Agenda
Village of Arlington Heights
Design Commission
Community Room, 3rd Floor

Arlington Heights Village Hall
33 S. Arlington Heights Road
Arlington Heights, IL 60005
November 28, 2017
6:30 PM

A. DC#17-138 - 703-723 W. Algonquin Rd. - Commercial

B. DC#17-143 - Favia Dental - 300 E. Northwest Hwy. - Sign Variation

NORTH EXTERIOR ELEVATION 1

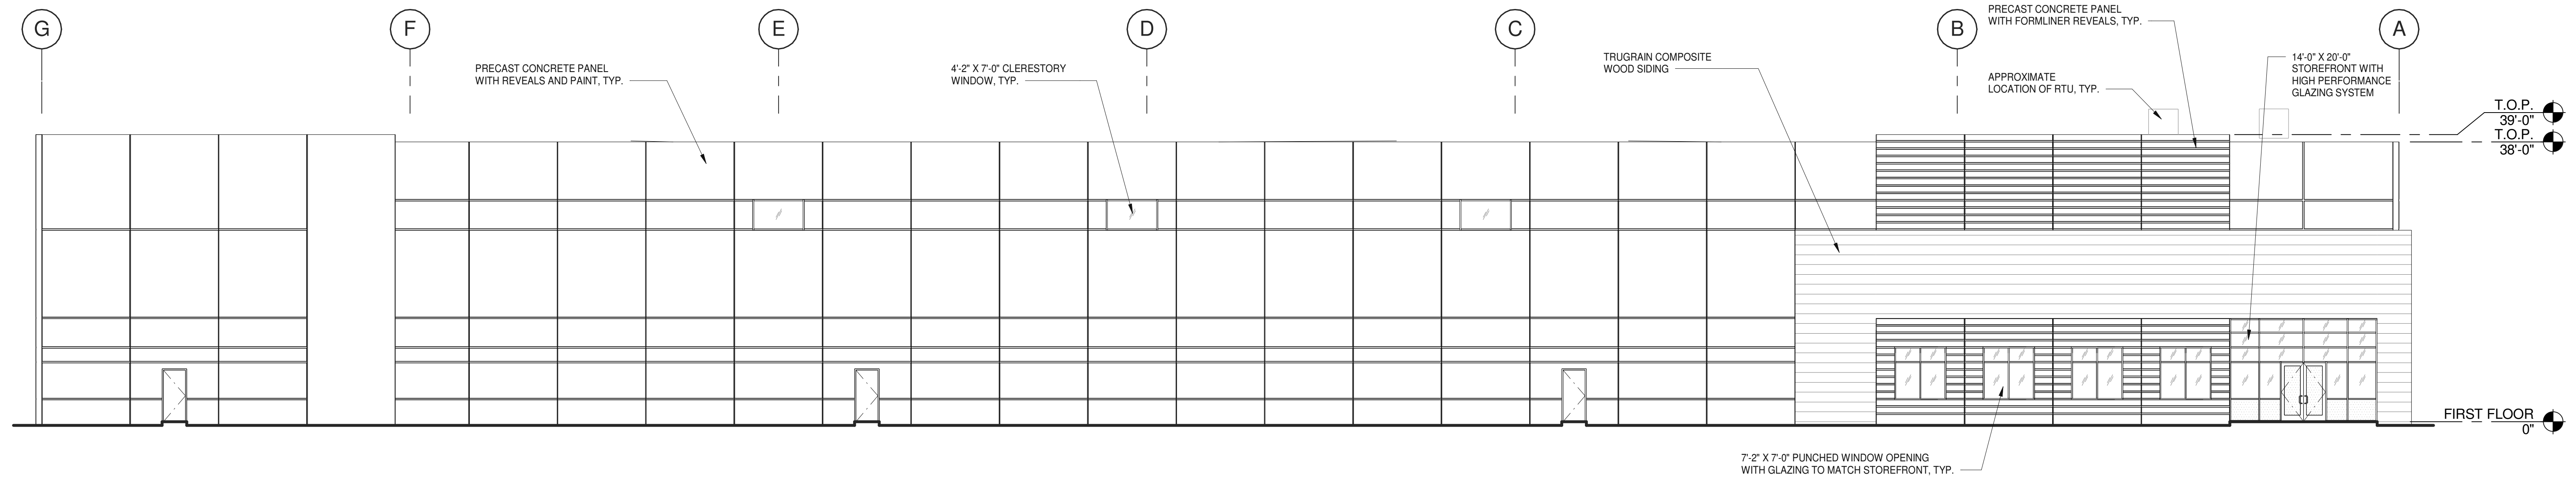
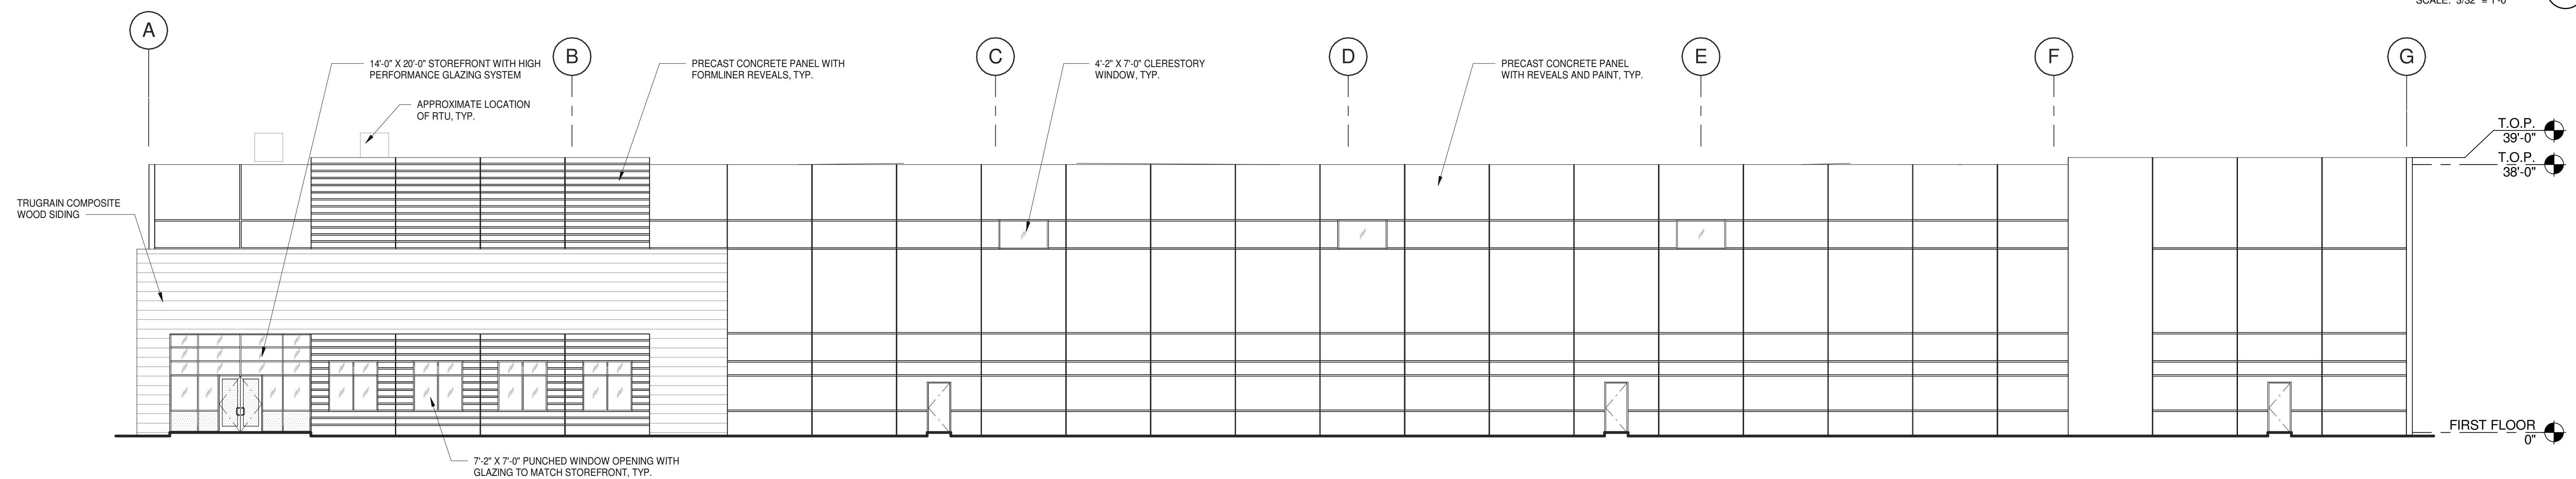
1. Consider adding more architectural detail at the northeast and southeast corners of the building using the composite wood siding and formliner precast panels.

Overall, the design is very nicely done. The only comment is to consider adding more architectural detail at the northeast and southeast corners of the building using the composite wood siding and formliner precast panels to enhance the building's appearance where visible from the roadways.

The building includes multiple rooftop mechanical units, some of which will be visible from the adjacent roads. The Village Design Guidelines require that all mechanical equipment be screened from public view. The rooftop units need to be screened from view by parapet walls, mechanical screens, or moving the units towards the middle of the roof to cut off the sight lines of the units. The petitioner should provide sight line diagram studies, and include mechanical screening where needed.

SHEET TITLE:
PHASE I
LANDSCAPE
PLAN

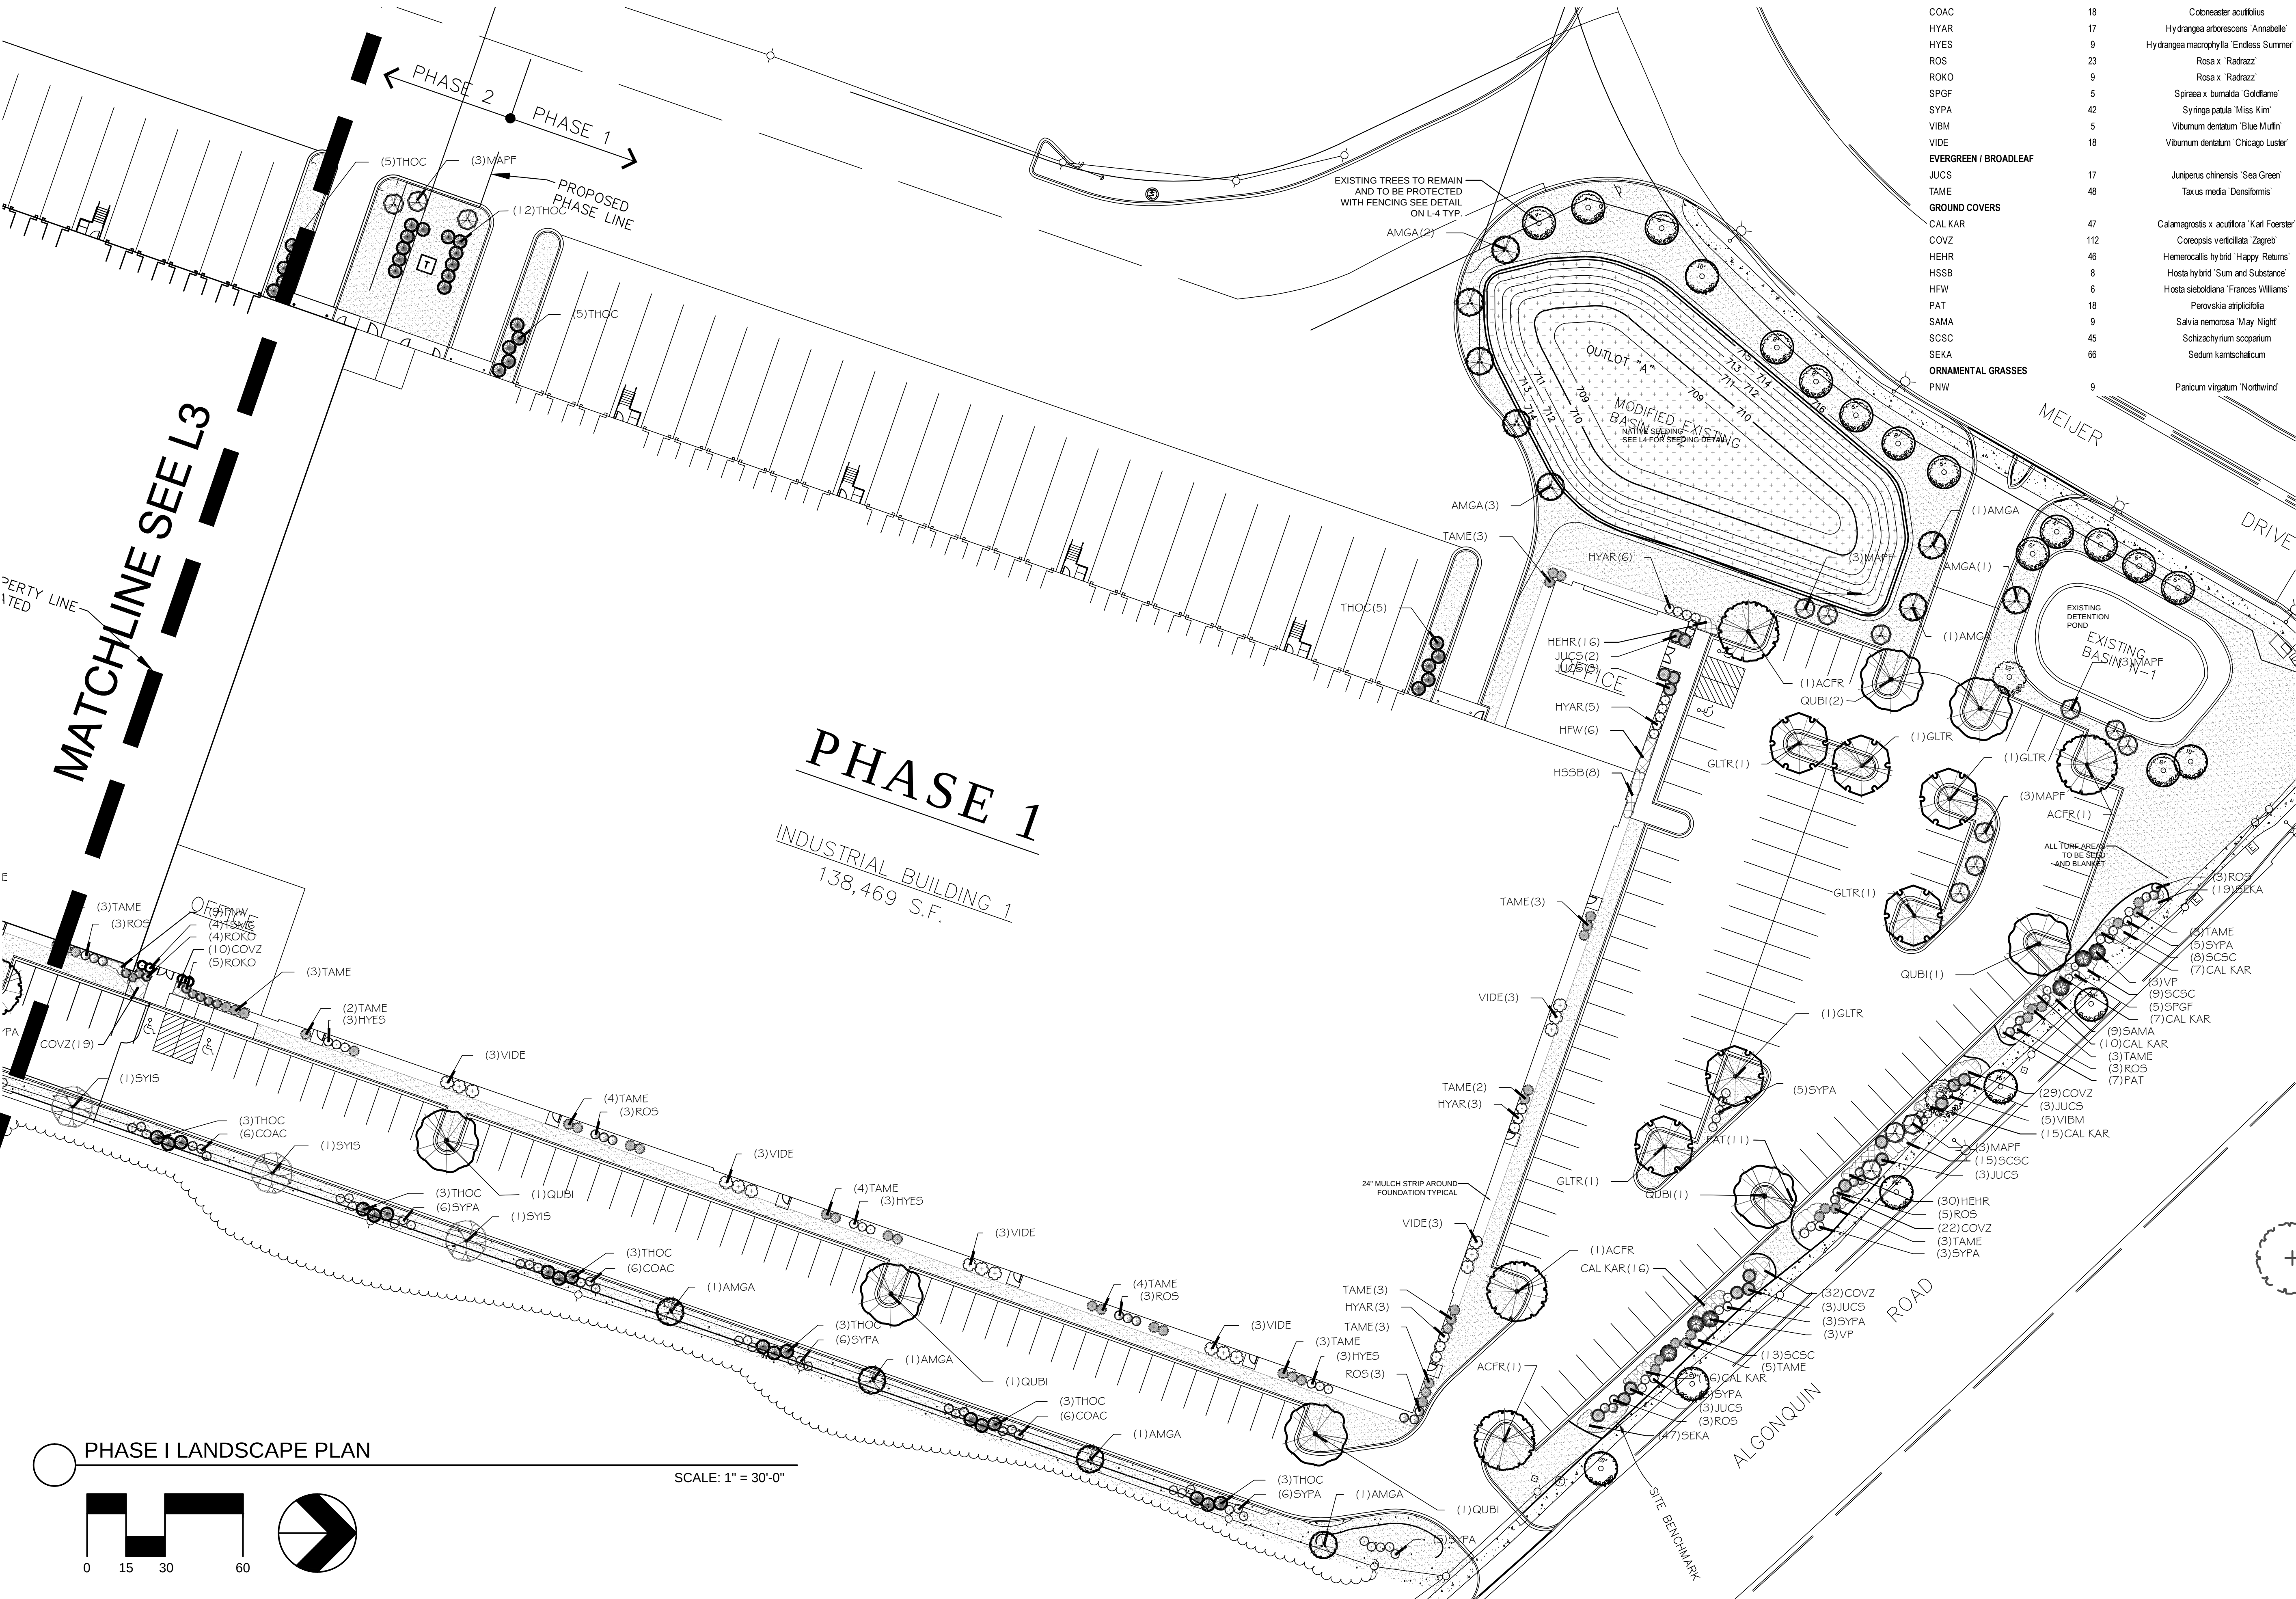
In regards to the landscape design, additional foundation plantings should be provided adjacent to the proposed building, especially along the north and south building walls adjacent to the roadways. The proposed plantings are minimal and should include a layering of understory trees, shrubs, and perennials.

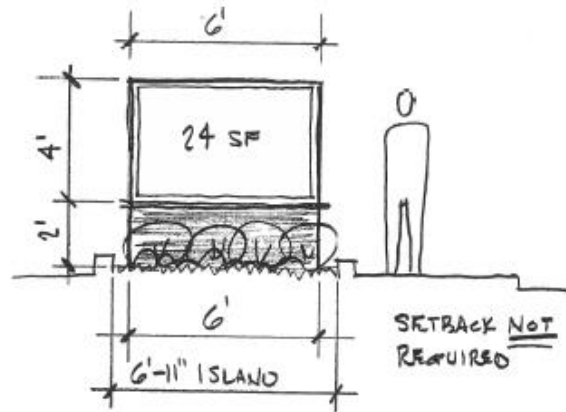
Option 1. A vertically designed code-compliant sign with a three foot setback to fit within the existing landscape island in the same location as the existing sign.

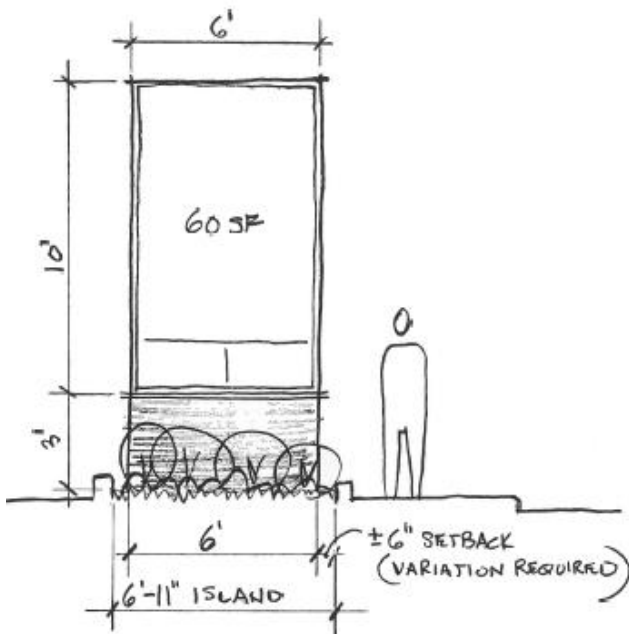
Option 2. A code-compliant monument style sign to fit within the existing landscape island. Monument style signs (six feet tall maximum) have no setback requirement.
